RE: Volvo Recall 216
Certain Model Year 2010 - XC60

VOLVO				TITLE:		GROUP:	NO:	
				Recall 216: Driver's Seat Side Cover		85	216	
Service Manager Bulletin						Model Year 2010 XC60		ISSUING DEPARTMENT: Warranty
				REFERENCE BULLETINS: PB 85-216 RTJ 22106				CARMARKET: United States, Canada
Service Person- nel: read and initial.	SERVICE MANAGER	SERVICE WRITER	WARRANTY ADMINISTRATOR			DATE:		
						YEAR	MONTH	DAY
						2009	11	20
Page 1 of 3

Recall 216: Driver's Seat Side Cover Panel Modification

Removing the rib material

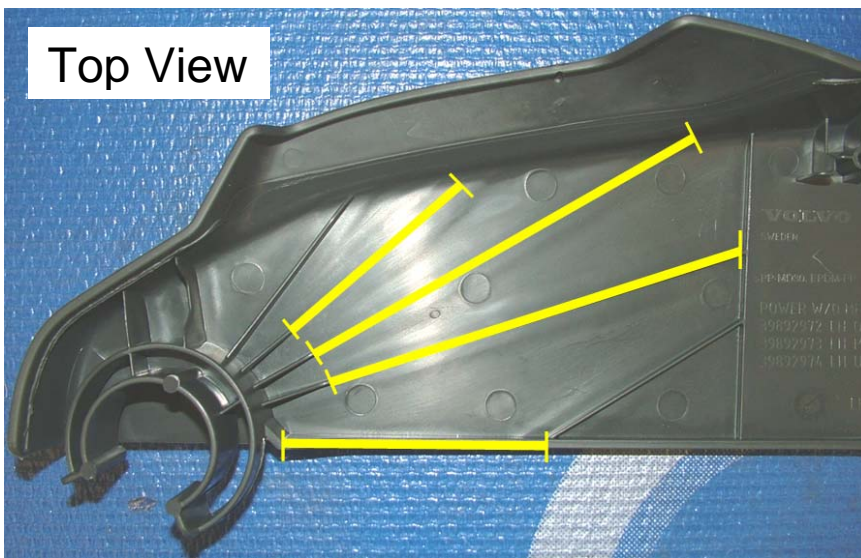
SERVICE: Remove the driver's seat cover panel and with the cover face down on a soft surface remove the panel reinforcement ribs as indicated in the following steps.

When removing the ribs place the cover face down on a protective material so you do not damage/scratch.

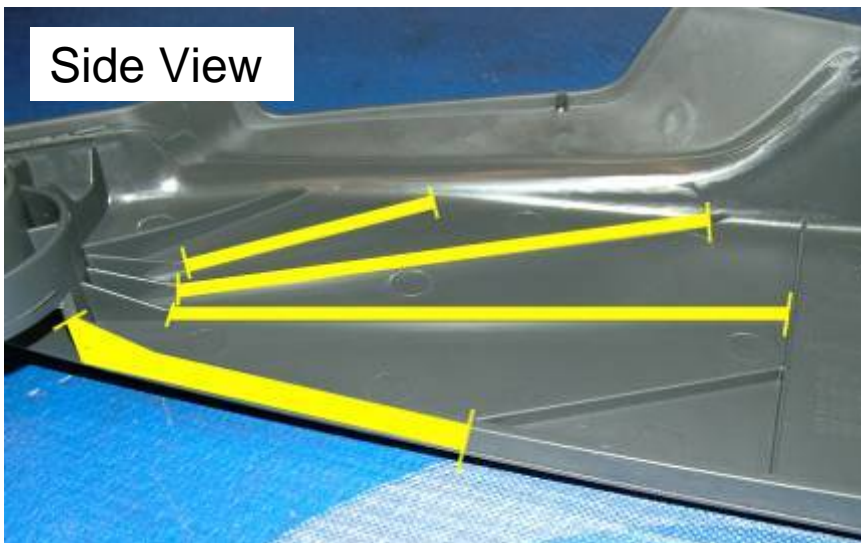
NOTE: Only remove the sections of the four ribs highlighted here. There is no need to remove additional material!

With the end cutting pliers cut off as much of the rib material from the back-side of the panel as possible.

After cutting with the end cutters use a small grinding tool to remove the remaining rib material from the back-side of the panel as shown here.
